Development Special Use Permit #2017-0015
Coordinated Development District Concept Plan #2017-0002
Special Use Permit #2017-0092, Encroachment #2017-0003
Transportation Management Plan SUP #2017-0097
200 Stovall Street - Hoffman Town Center Block 6A

Applicant	General Data	
Project Name: Hoffman Town Center, Block 6A Location: 200 Stovall Street Applicant: Perseus Realty, LLC	PC Hearing:	September 7, 2017
	CC Hearing:	September 16, 2017
	If approved, DSUP Expiration:	N/A*
	Plan Acreage:	1.5 acres (65,161 sq. ft.)
	Zone:	CDD #2
	Proposed Use:	Residential and Retail
	Gross Floor Area:	Residential: 594,108 sf Retail: 36,475 sf
	Small Area Plan:	Eisenhower East
	Green Building:	LEED Certified for residential; requesting flexibility for retail

Development Special Use Permit #2017-0015
 Coordinated Development District Concept Plan #2017-0002
 Encroachment #2017-0003
 Special Use Permit #2017-0092
 Transportation Management Plan SUP #2017-0097
 200 Stovall Street

ENCROACHMENTS ALONG SWAMPFOX ROAD

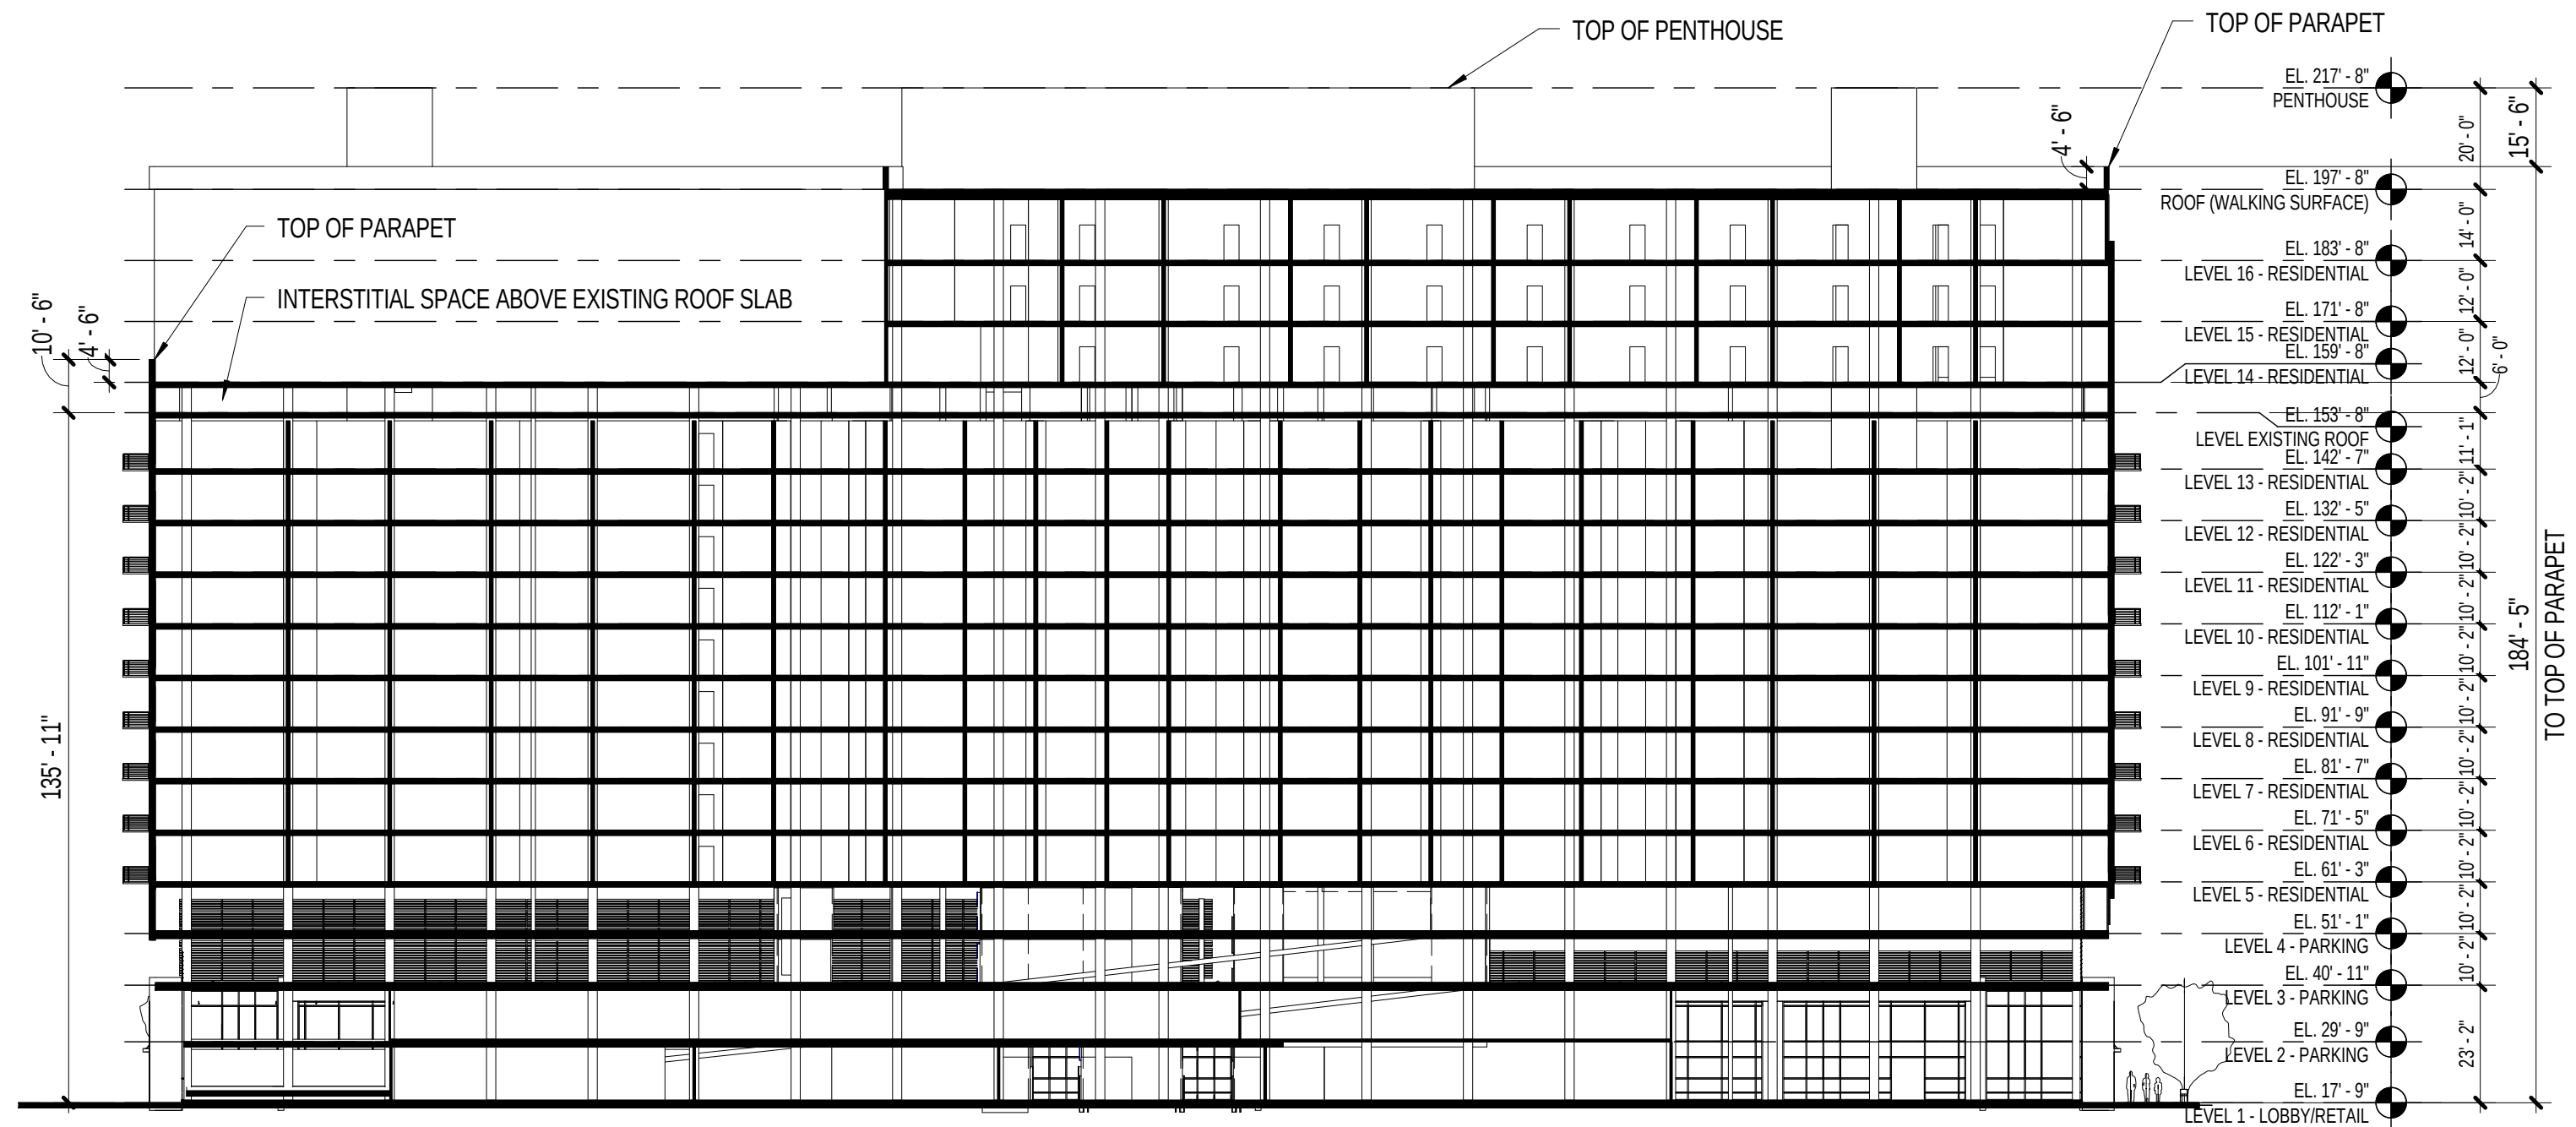
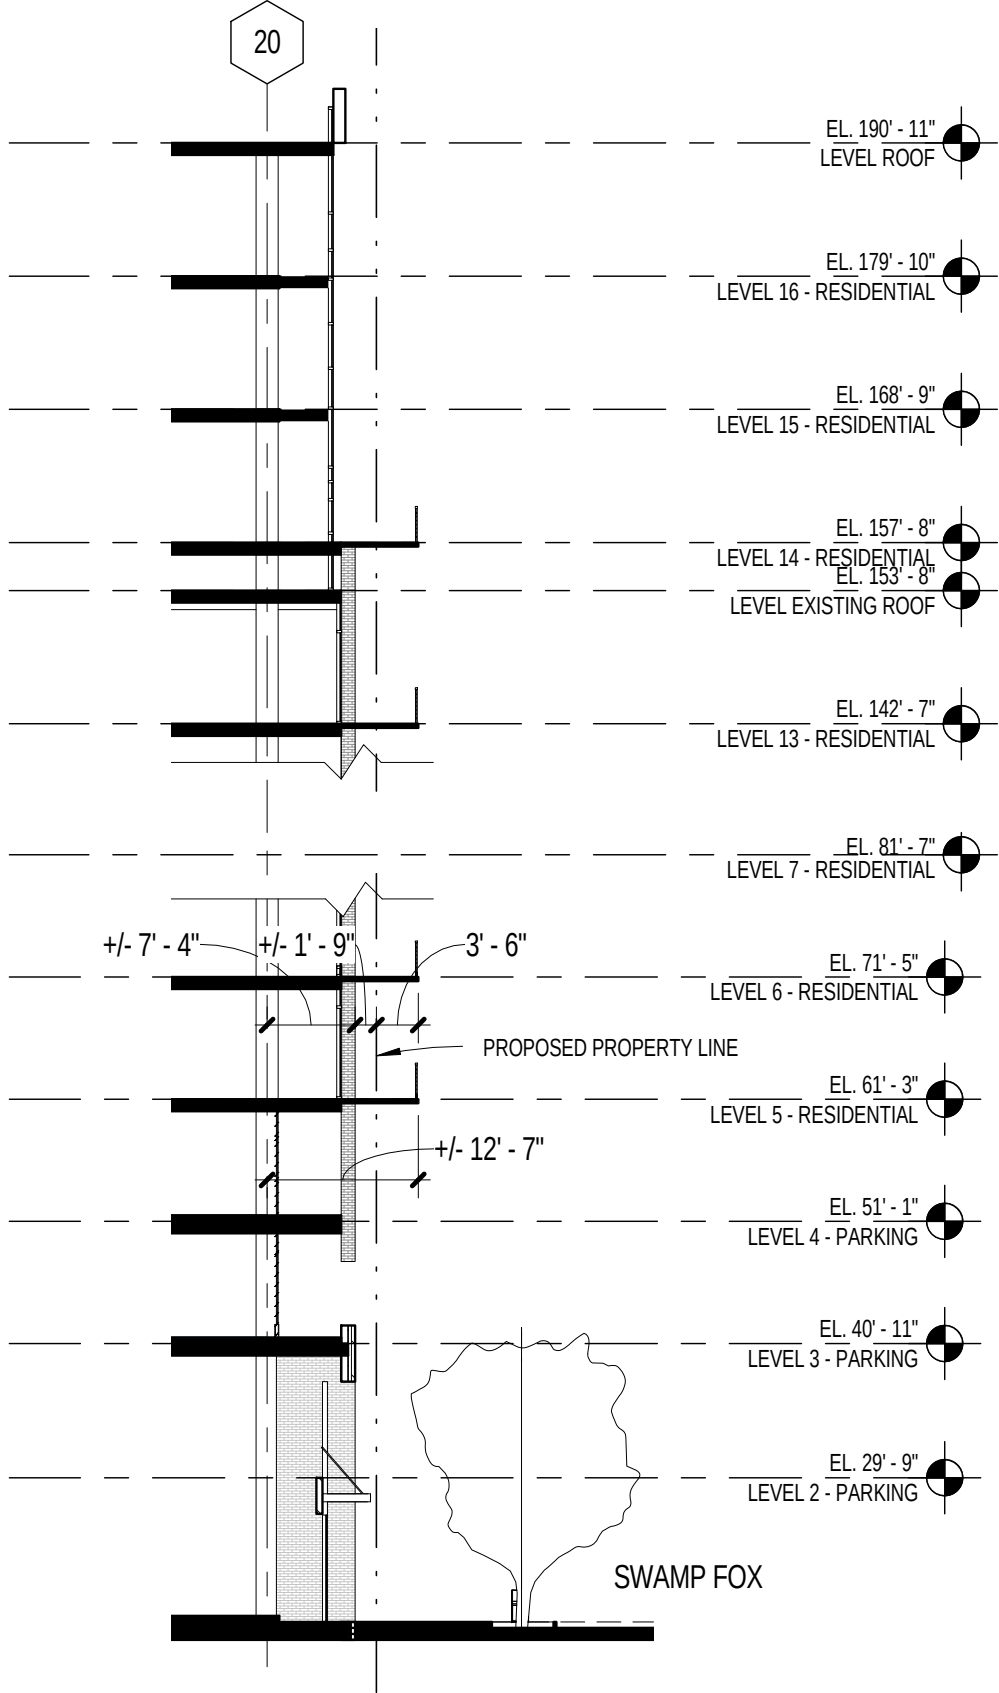
- **An Encroachment (ENC2017-0003);** A request for residential balconies to extend 3'-6" into the public right-of-way on Swamp Fox Road.
- **A Transportation Management Plan Special Use Permit Amendment to TMP SUP1998-0043;** A minor amendment to previously approved TMP SUP#1998-0043 to amend Condition #9 to update the commercial use rate, and include residential and retail uses and their associated rates.

The applicant proposes apartment units on floors five through sixteen of the building. In order to promote the marketability of the units, and to provide a variety of options to the tenants, two kinds of residential balconies are offered: (1) Balconies that are flush with the face of the building, located on the north and south facades, and (2) Balconies that protrude from the face of the building, located on the east and west facades. On the east façade, which faces Swamp Fox Road, the property line is located approximately 1’-9” from the face of the building. For this reason, the applicant requests an Encroachment for the residential balconies of 3’-6” into the public right of way at this location only.
